Change Notification

Change No.: PCN240215CV

FN351-8-29
FN351H-8-29
FN351-16-29
FN351H-16-29
FN356-16-29

Before:

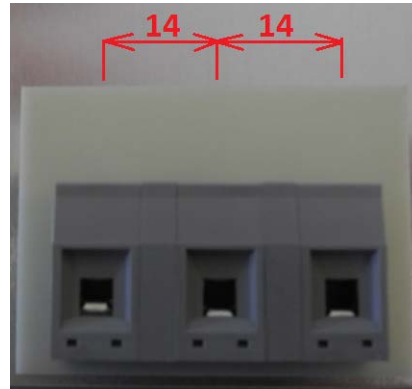
For UL-File-Review => to be compliant with UL1283 5th Ed.
Spacer added between terminals. Space between terminals now 14mm.
